**CITY OF BATON ROUGE
PARISH OF EAST BATON ROUGE**

ADDENDUM NO. 1

**SUBJECT: GLASGOW AVENUE SIDEWALKS PROJECT
CITY-PARISH PROJECT NO. 24-EN-HC-0026**

WEIR INLET

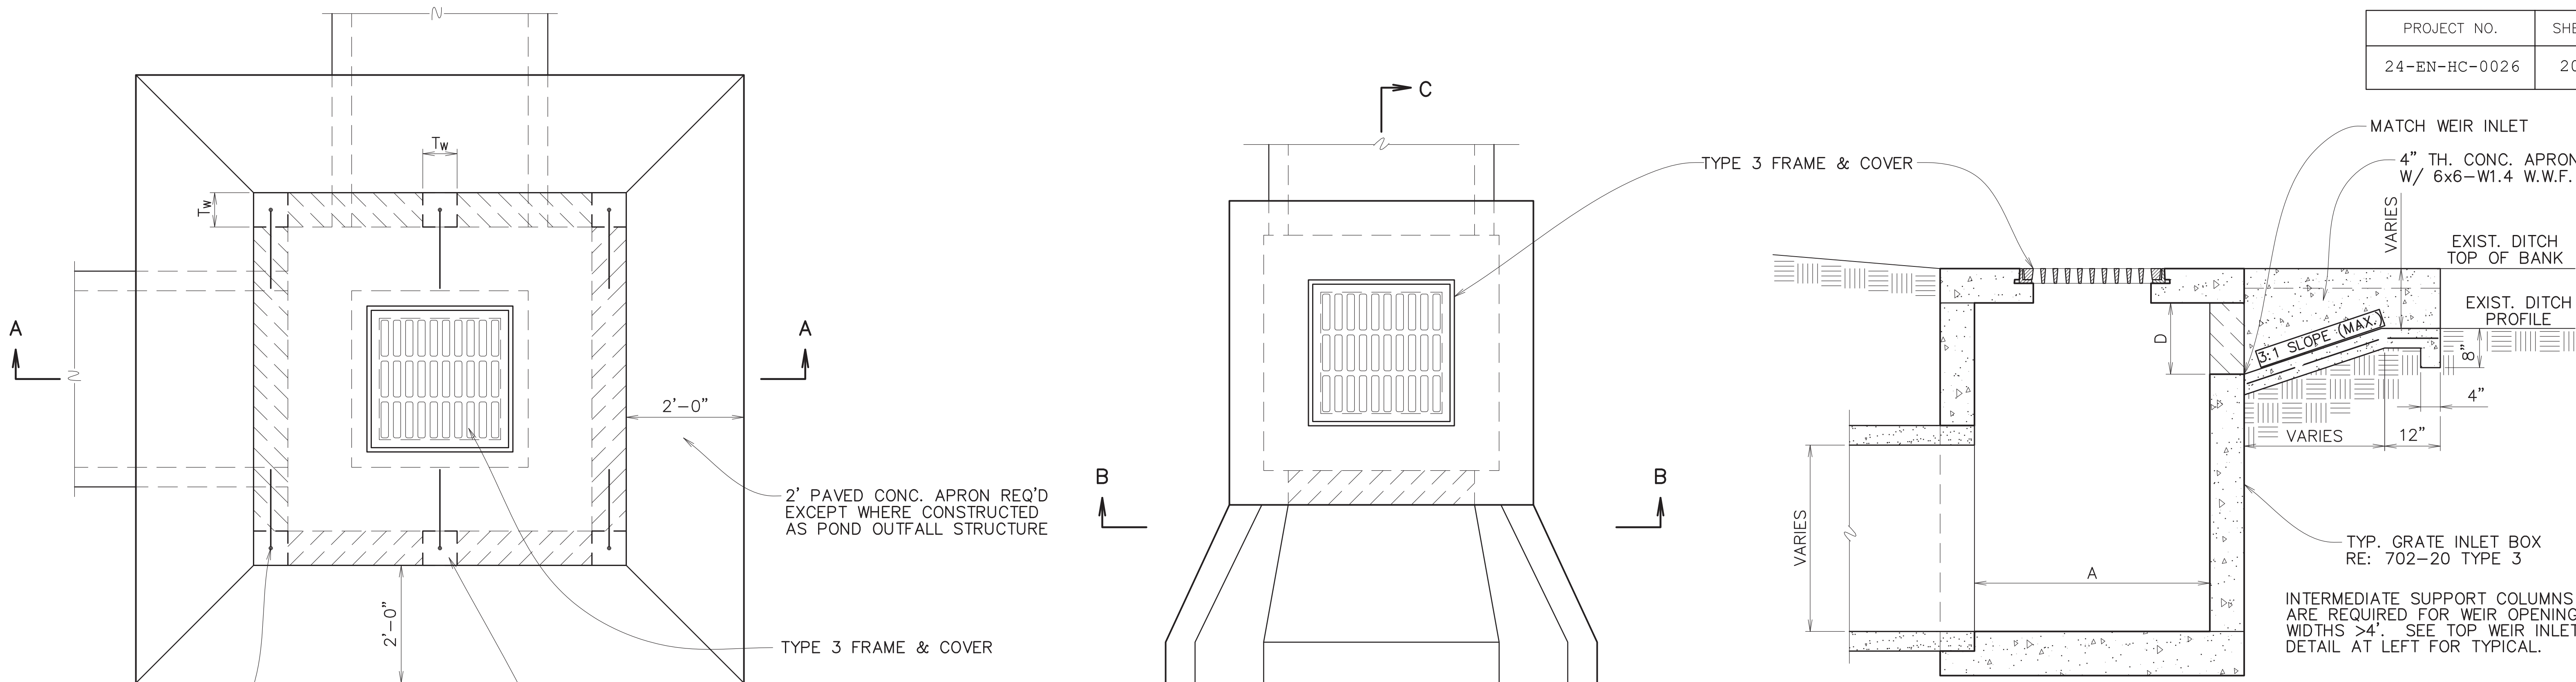
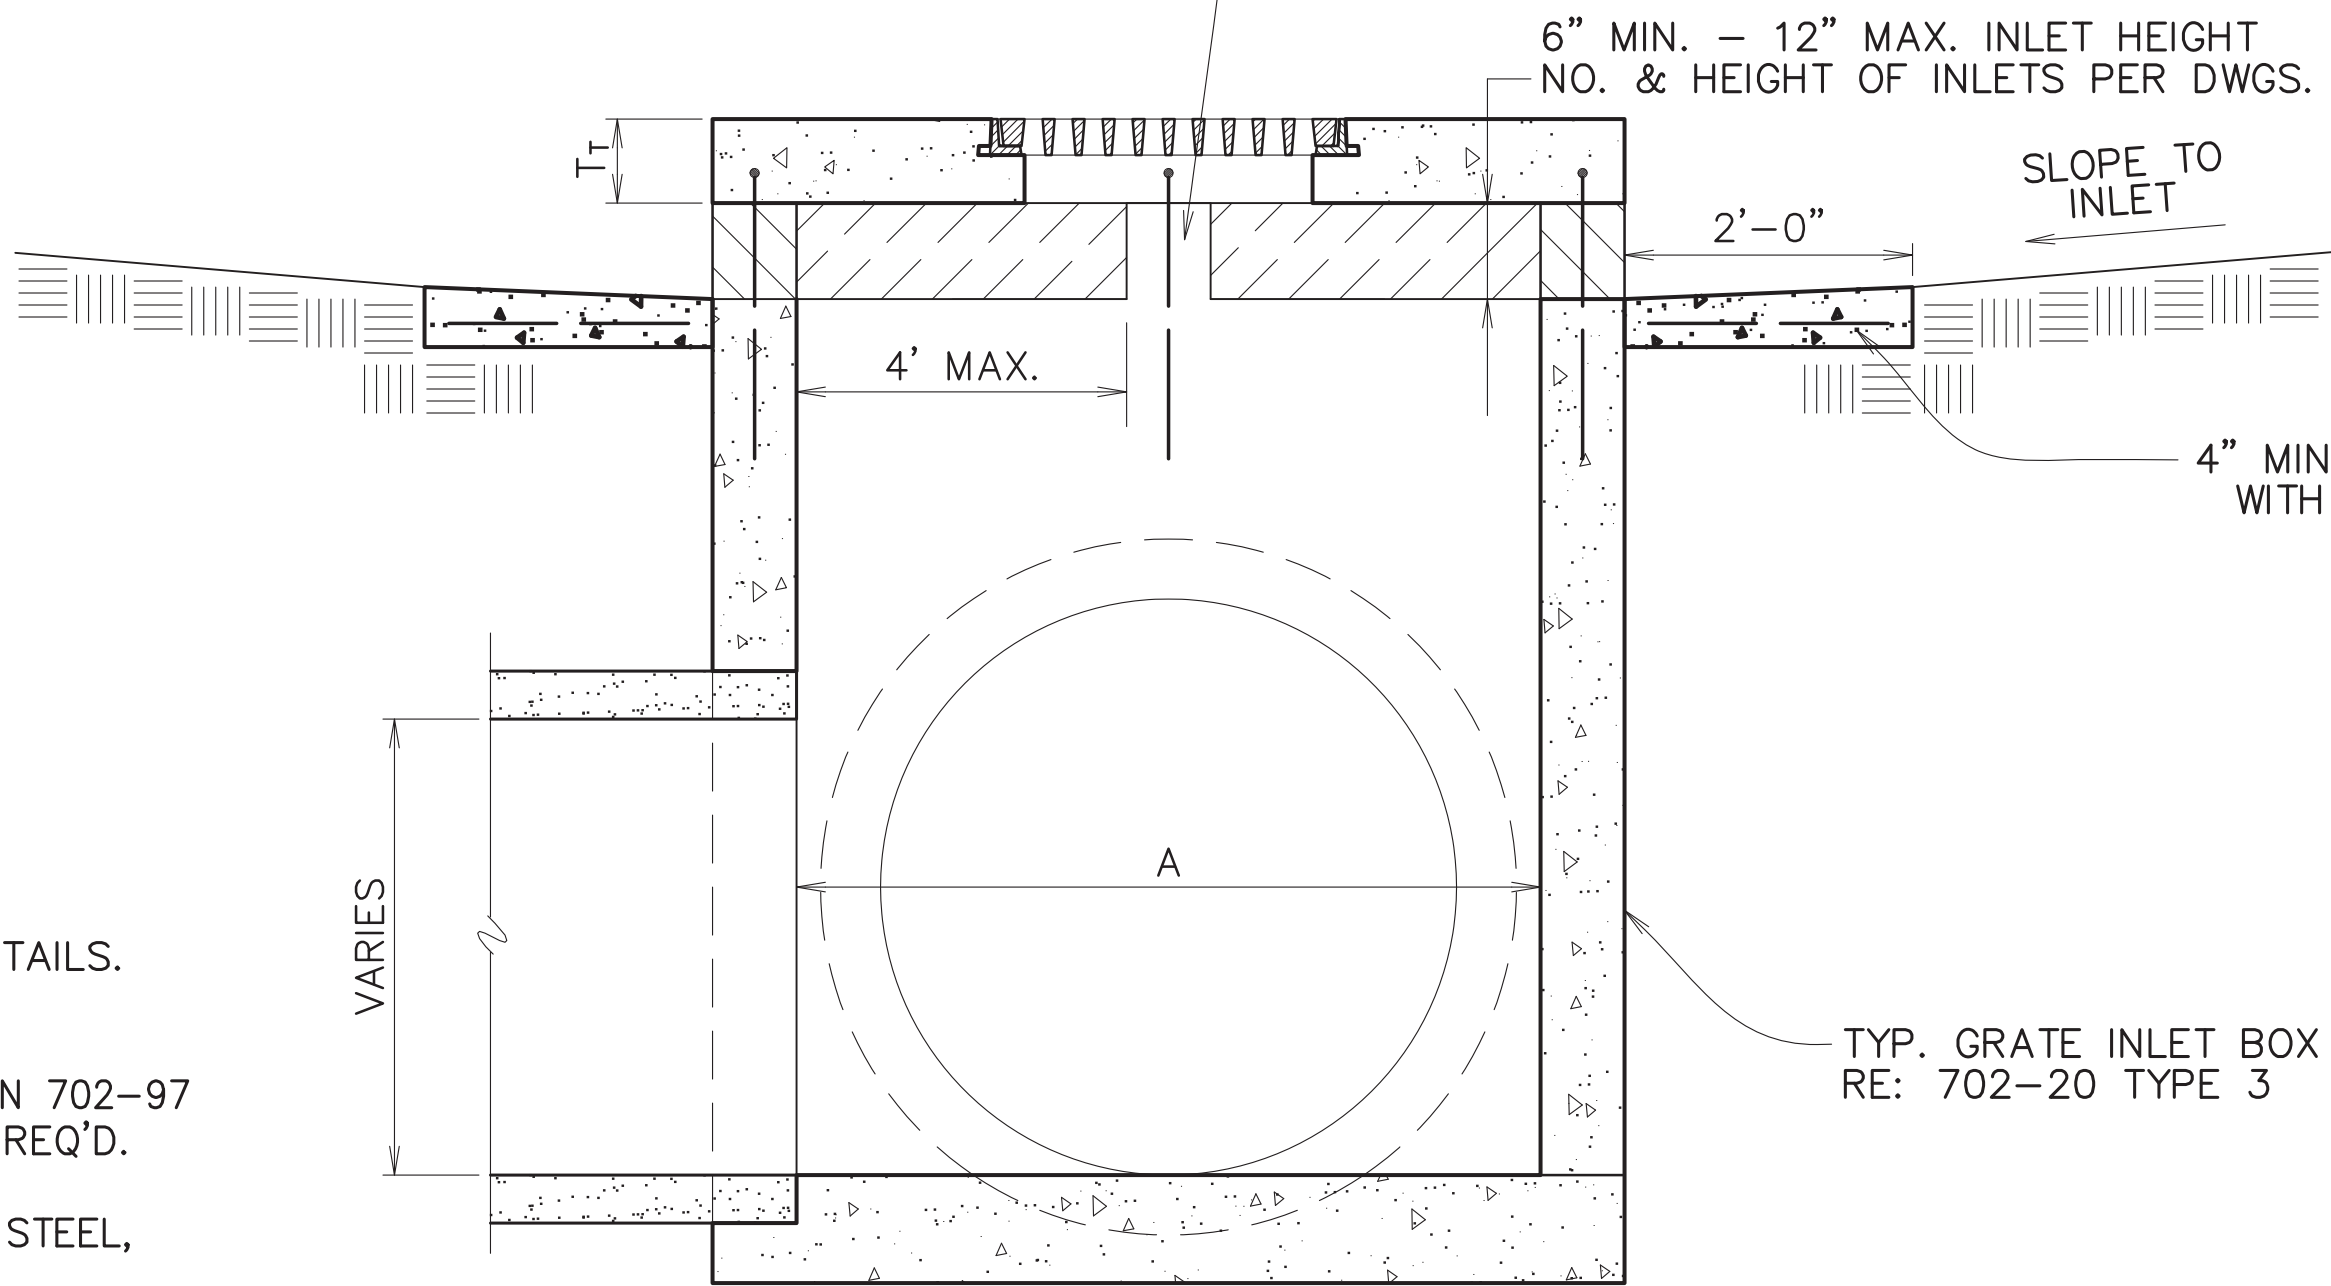
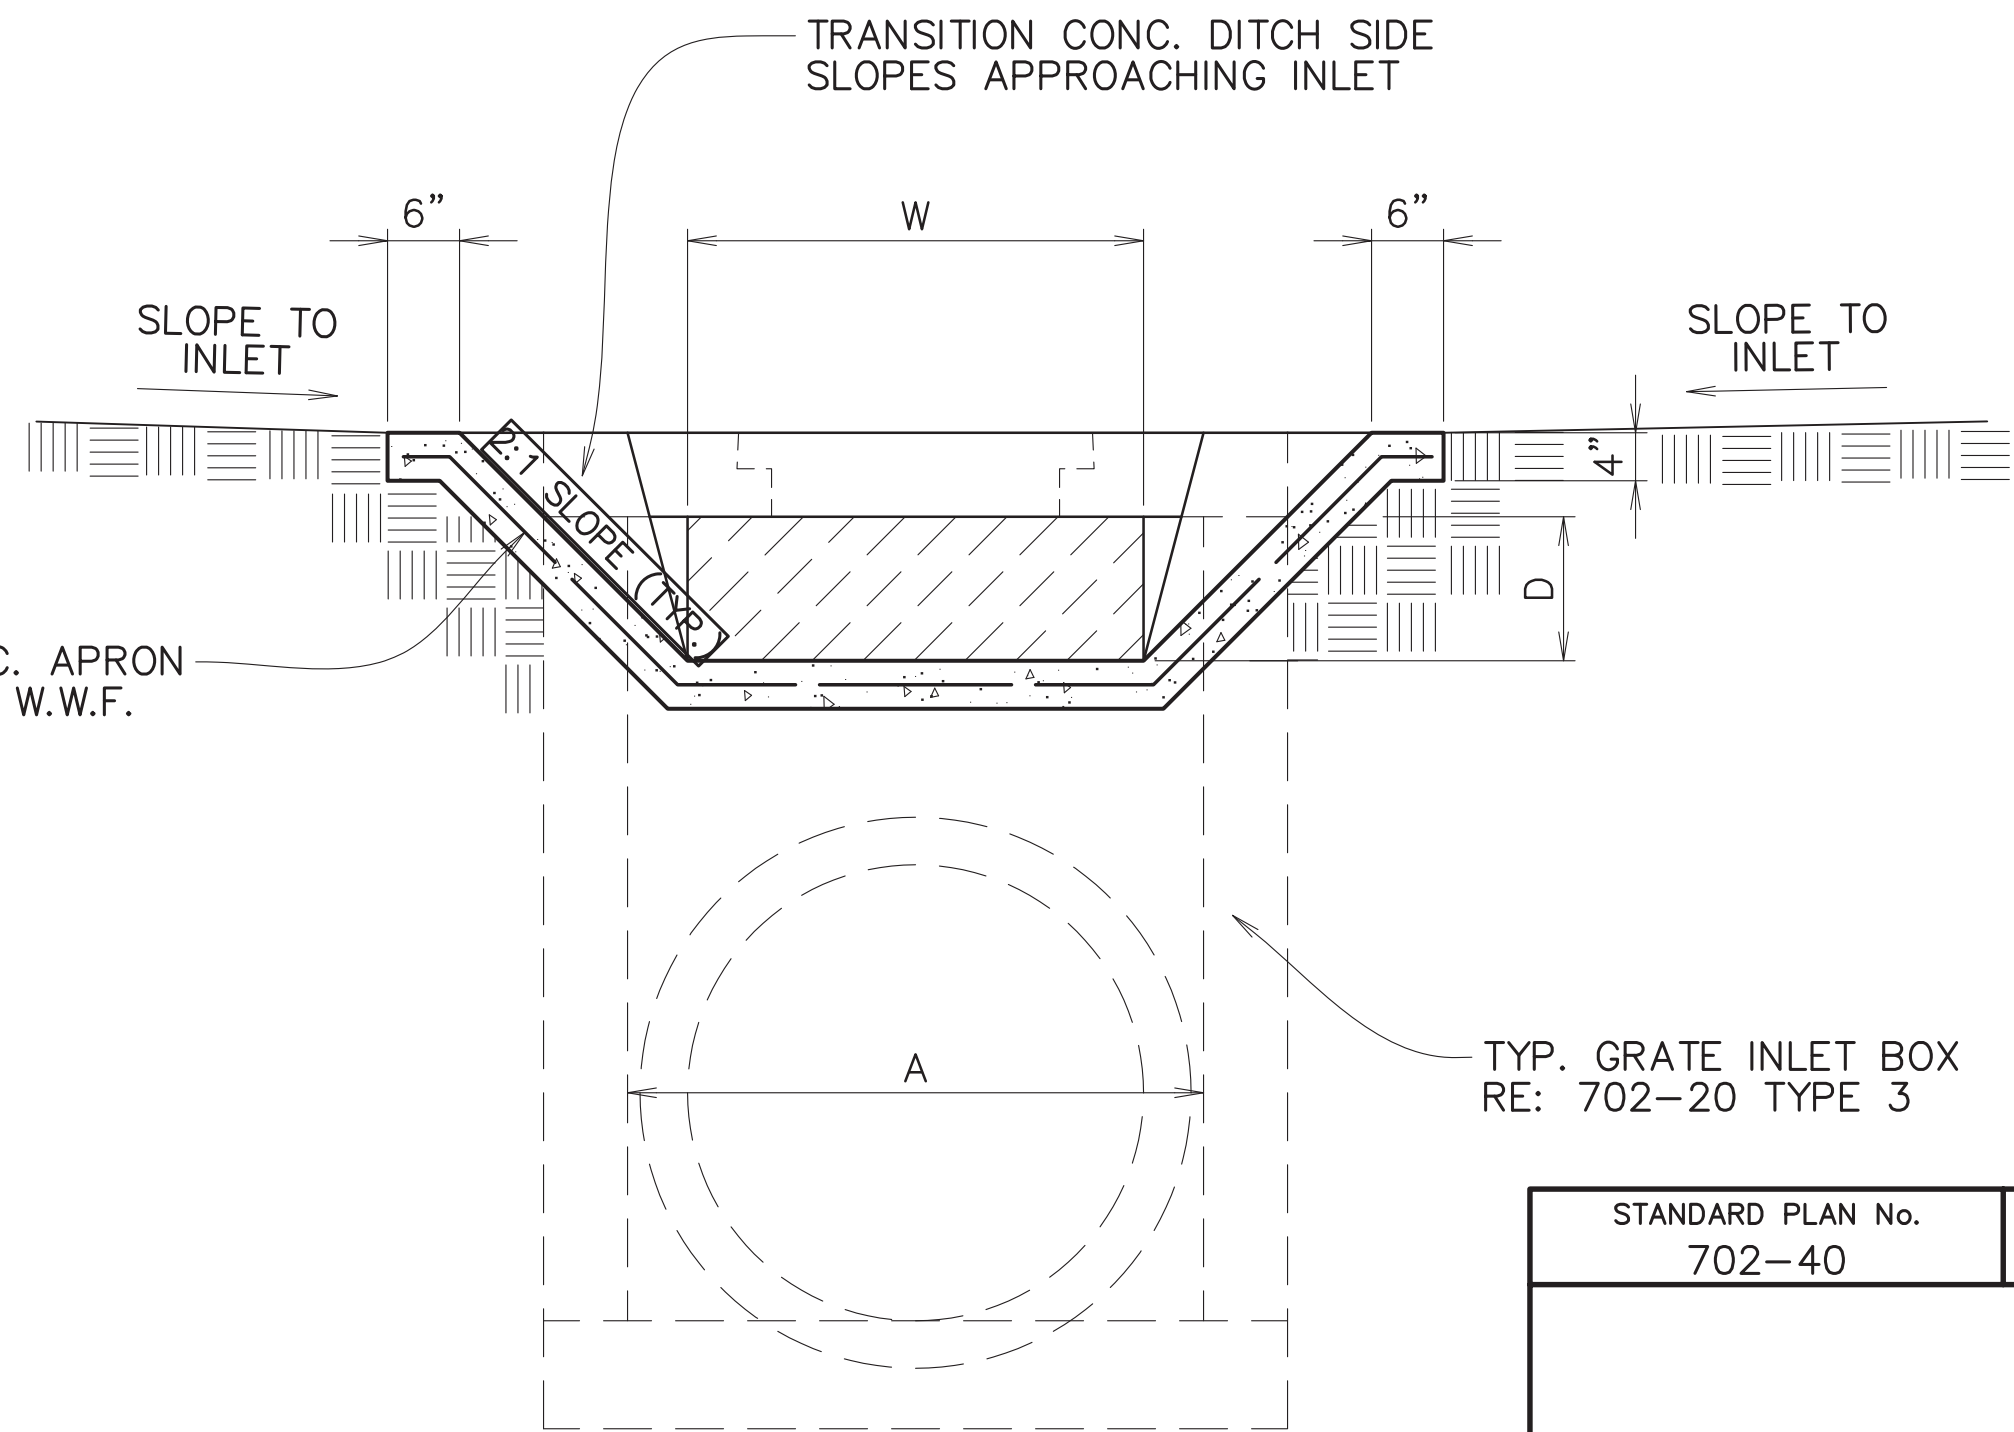
4. Is the 5' Sidewalk shown on sheet 204 for the side weir gate included in that item?
 - ***Response: Sheet 204 should be standard detail 702-40 Weir Inlet, referencing the side weir inlet without the 5' sidewalk. Standard detail 702-41 should be deleted.***
